OUTLINE OF NEW FEATURES

The following changes have been made to the new FJ Cruiser.

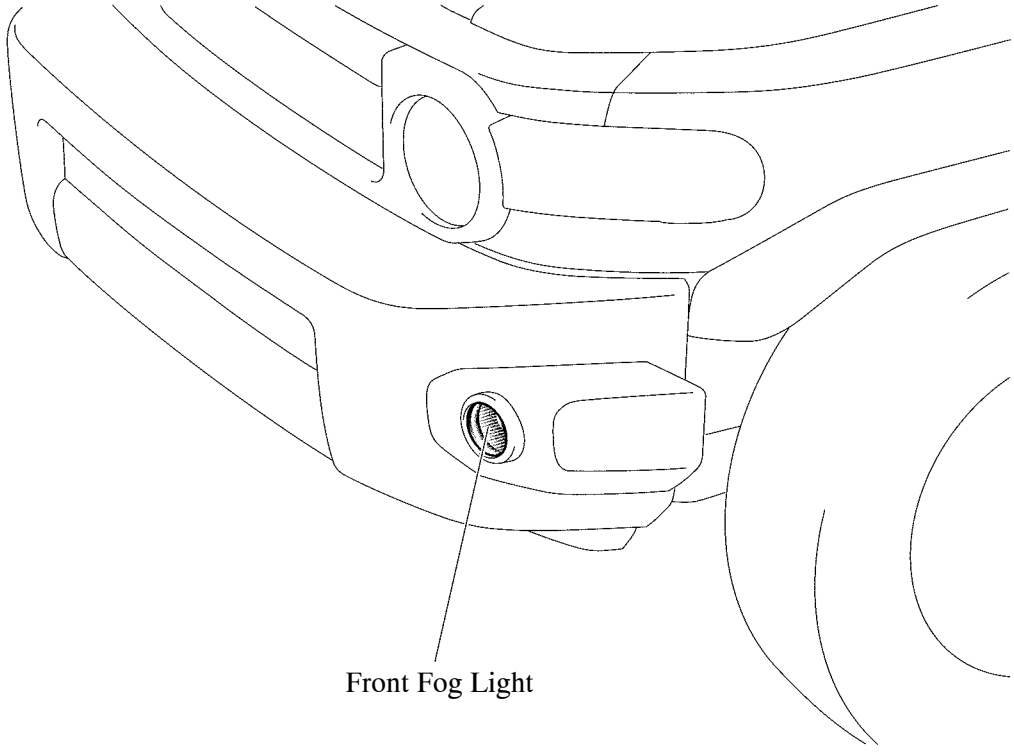
- Specifications for 1GR-FE engine for Chile package models have been modified for compliance with EURO V regulations* from EURO IV regulations. For details, see page 7.
- The provision of the sub fuel tank for Chile package models has been abolished.

6. Combination Meter

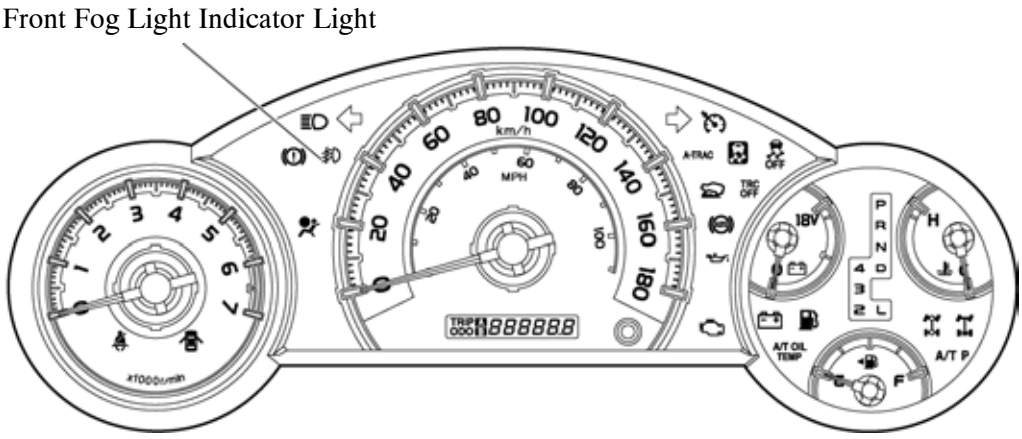
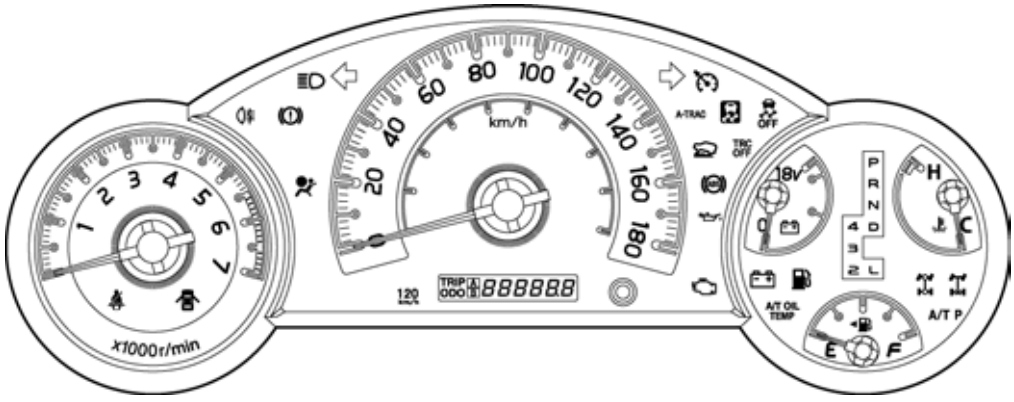
- The design of the face of the combination meter assembly has been changed.
- A front fog light indicator light has been provided for the models equipped with fog light assembly.
